TOWN OF JONESBOROUGH  
Town Hall Board Room  
123 Boone Street  
Jonesborough, TN 37659

# TREE & TOWNSCAPE COMMITTEE

SUBJECT: BRADFORD PARK

**SITE AND LANDSCAPE PLAN**  
**BRADFORD PARK**  
PRESIDENTIAL DRIVE  
JONESBOROUGH, TENNESSEE

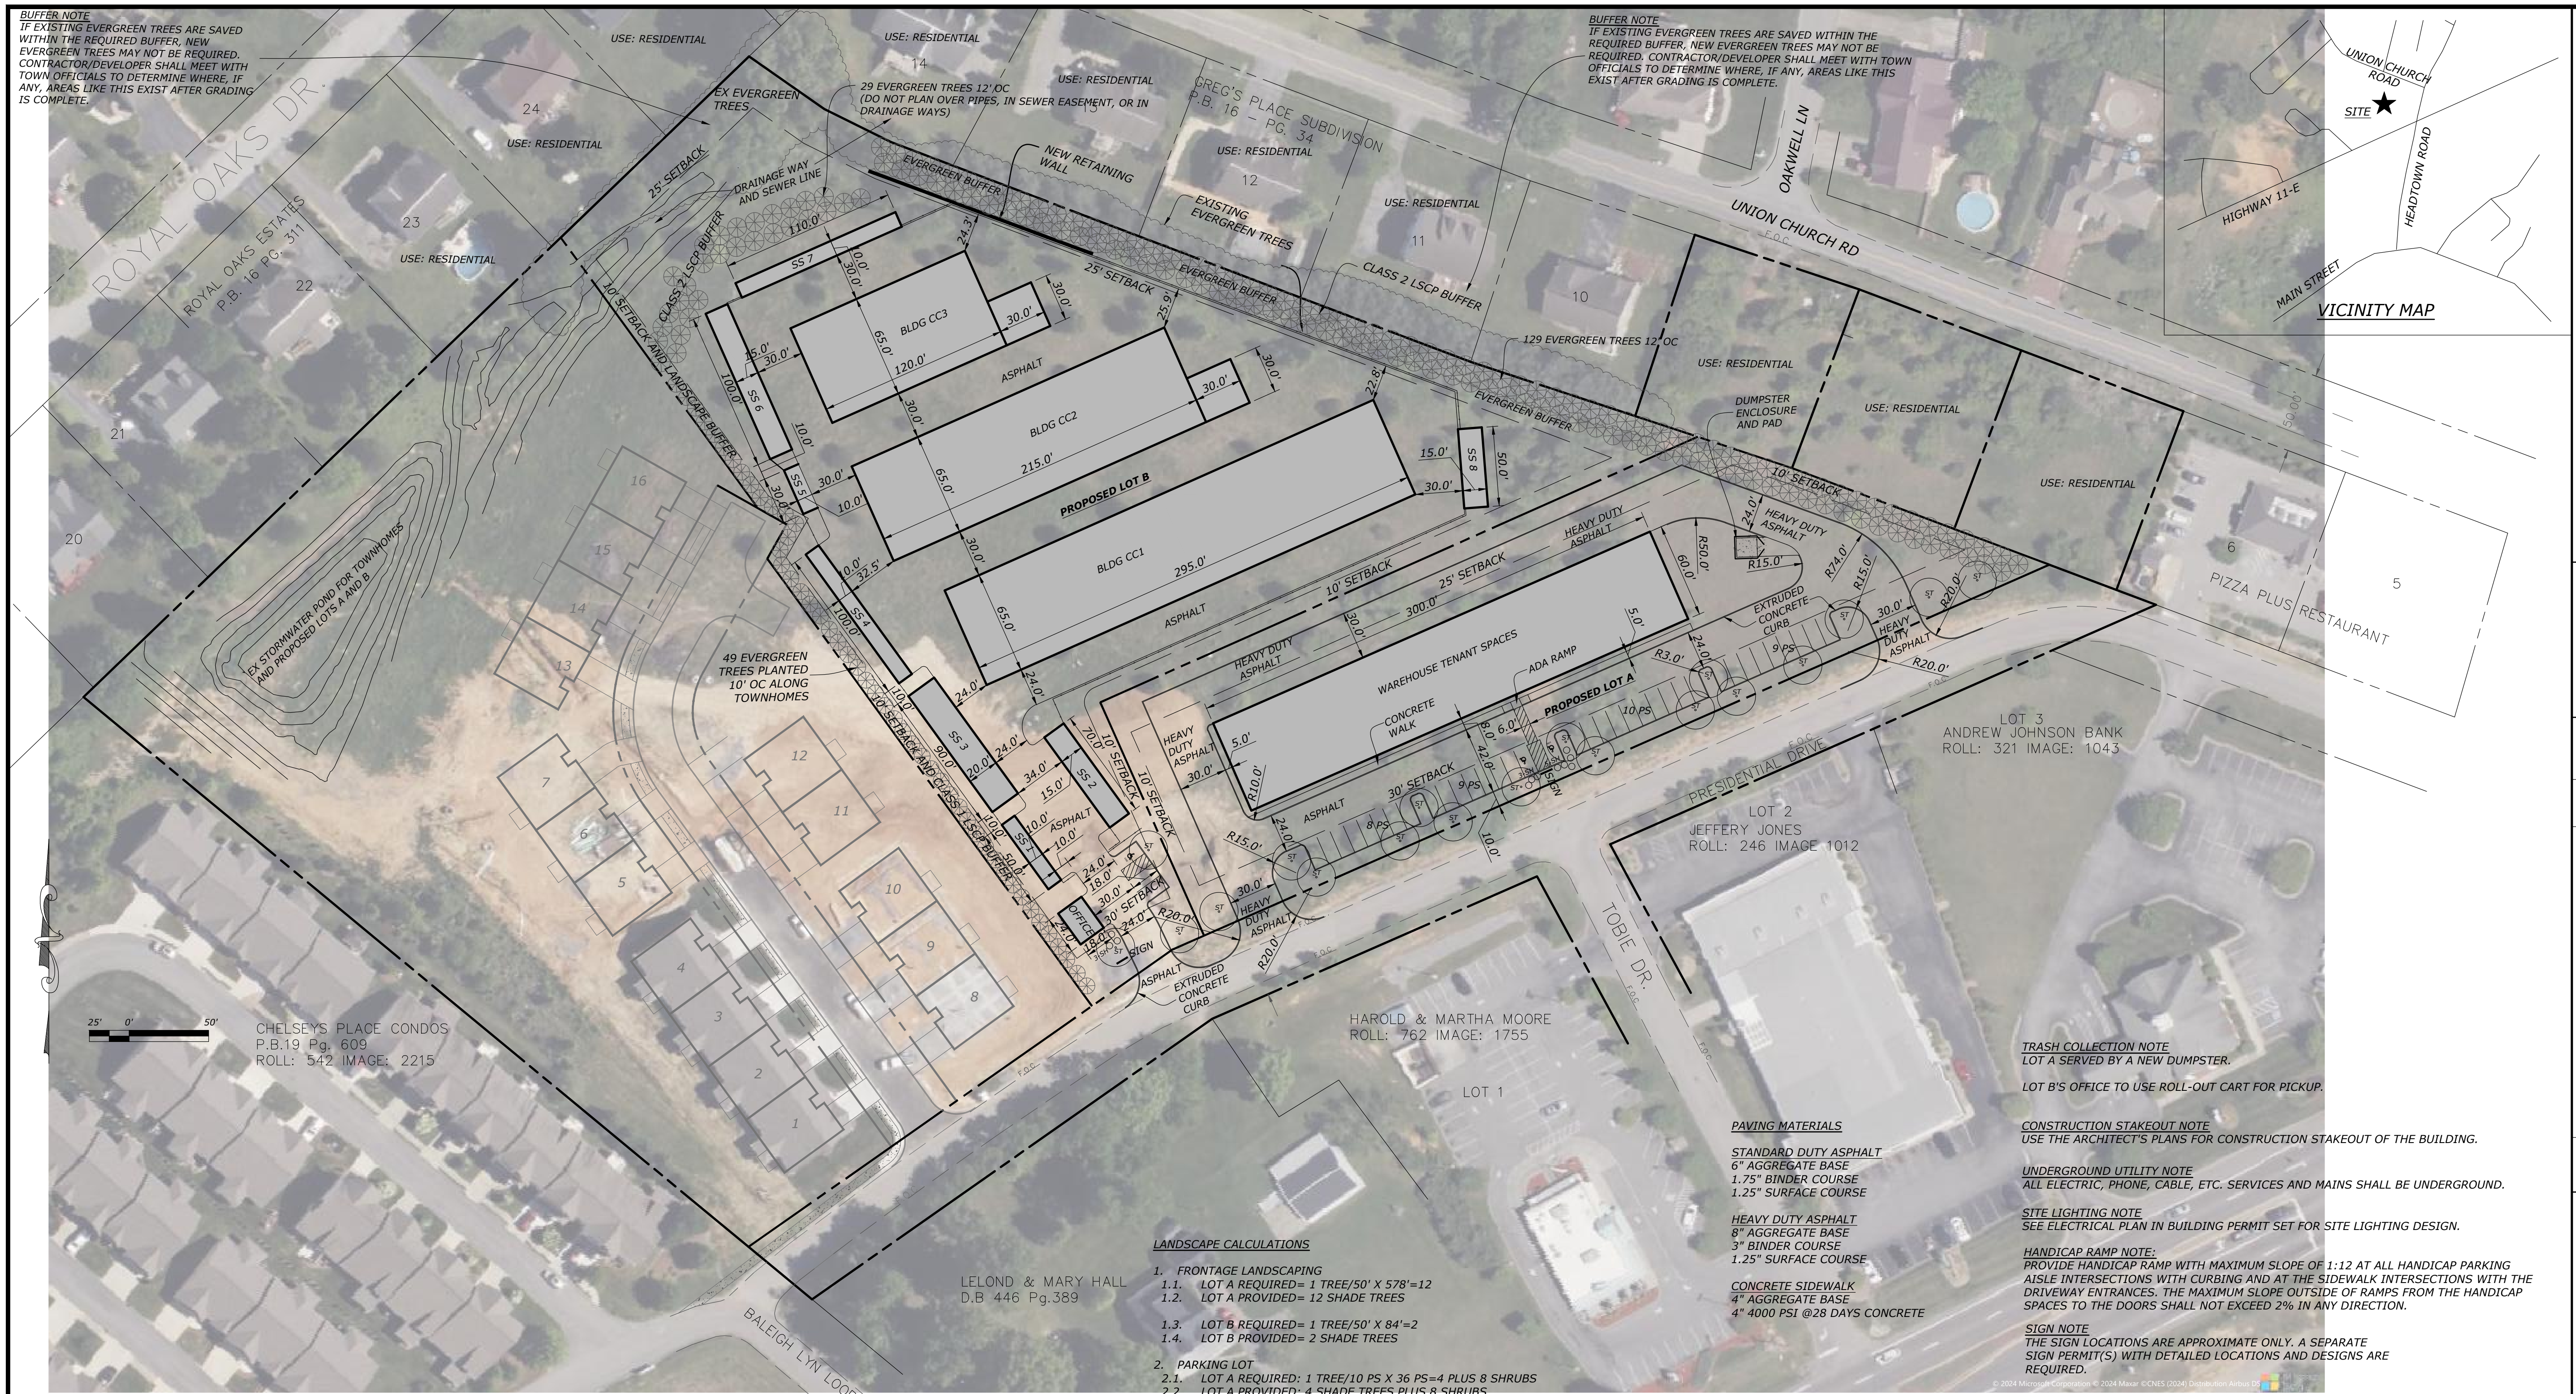
The land use of the properties to the north, east and west are residential. The townhomes to the east of the Bradford Park property require a class 1 buffer and the single-family homes to the north and northwest respectively require a class 2 buffer.

This note from the developer justifies why the evergreen trees placed as the class 1 buffer are 10' on center rather than 8' on center per the Landscape Requirements:

This note from the developer states that existing evergreen trees may satisfy partial or all of the class 2 buffer requirements against the residential property line:

A class 1, option A1, buffer with 49 evergreen trees has been provided to buffer against the residential townhomes. 1 tree/10' OC x 490 LF = 49 trees.

A class 2, option C2, buffer with 158 evergreen trees has been provided to buffer against the residential single-family homes. 1 tree/12' OC x 950 LF = 79 trees x 2 rows = 158 trees.

The south side of the property facing Presidential Drive will require road frontage landscaping. The linear feet listed is divided into two sections, A & B. The frontage for Lot A is listed as 578' LF and the frontage for Lot B is listed as 84' LF. The road frontage requirements include 1 tree for every 50'. 1 tree/50' x 578' = 12 trees required for Lot A. 1 tree/50' x 84' = 2 trees required for Lot B.

39 parking spaces have been provided in Lot A. 1 tree is required for every 10 parking spaces with at least 2 shrubs per tree.  $1 \text{ tree}/10 \text{ spaces} \times 39 \text{ spaces} = 4 \text{ trees}$  and at least 8 shrubs.

3 parking spaces have been provided in Lot B. 1 tree is required for every 10 parking spaces with at least 2 shrubs per tree.  $1 \text{ tree}/10 \text{ spaces} \times 3 \text{ spaces} = 0.3$  or 1 tree and at least 2 shrubs.

The landscape plan does meet the minimum standards as per the town's Landscape Requirements.

Approve the landscape plan as submitted.
